Project 200609 -Supplemental Information Requested by City of Cambridge, Slab

Evaluation, Riverview Condominiums, 221 Mt. Auburn Street,

Cambridge, MA

We prepared this letter to supplement our Slab Evaluation report dated 7 February 2025.

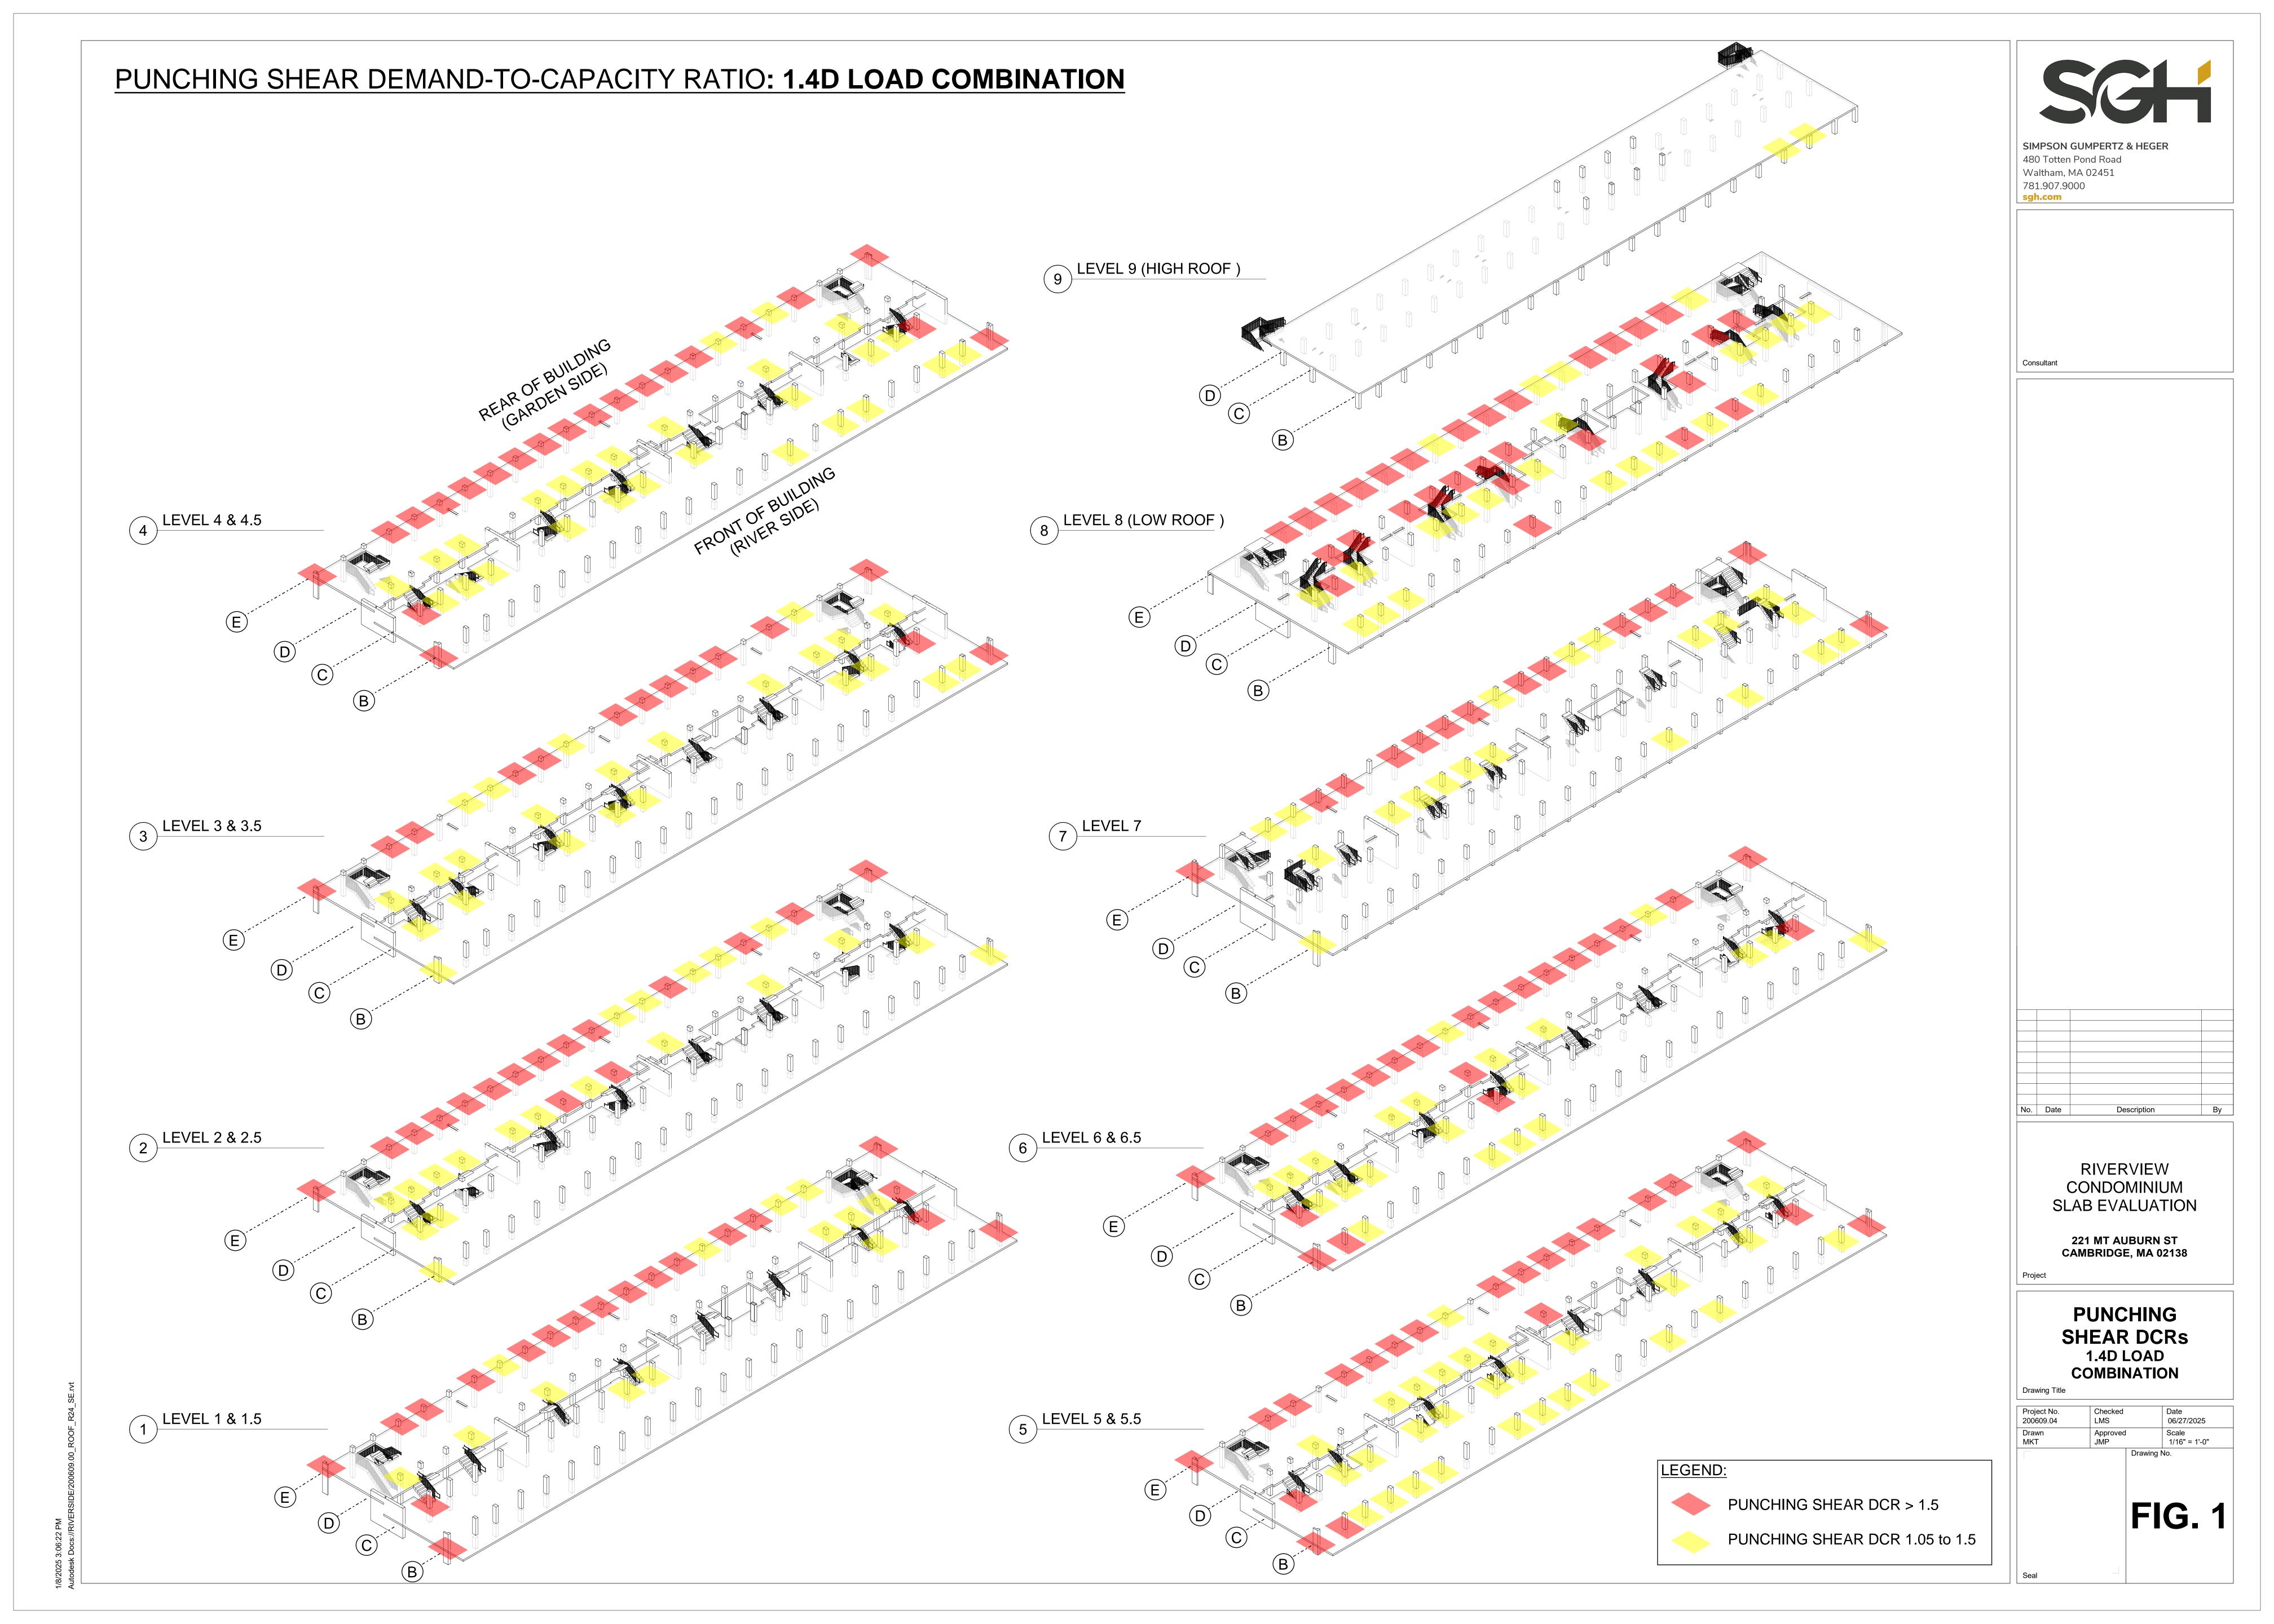
We graphically show the DCRs in Figure 1 (1.4D load combination) and Figure 2 (1.2D  $\pm$  1.6S load combination).

Figure 1 (1.4D load combination) shows that many column-slab connections have punching shear DCRs greater than 1.5 under dead-load only (i.e., the self-weight of the structure). Similarly, Figure 2 (1.2D + 1.6S load combination) also shows many locations with DCRs greater than 1.5, in particular at the High Roof and Low Roof slabs, due to snow loads. ACI 562 Commentary states that "the demand-to-capacity ratio for unsafe conditions was developed consistent with the performance-based procedures" contained in American Society of Civil Engineers and Structural Engineering Institutes – Minimum Design Loads and Associated Criteria for Buildings and Other Structures (ASCE/SEI 7-16)<sup>1</sup> and that "a demand-to-capacity ratio greater than 1.5...represents a condition with limited to no margin of safety against failure for ASCE/SEI loads."

exceed 1.5 when exposed to dead load alone (Figure 1). This prompted our recommendation in fall 2024 to shore the structure, we notified the City of the structural issues, and, concurrently, the Riverview Board of Trustees began planning to move residents out of the building.

We previously recommended shoring the structure due to the "potentially dangerous" categorization, consistent with ACI 562 recommendations; however, shoring has significant challenges as summarized in Section 3 of this letter.
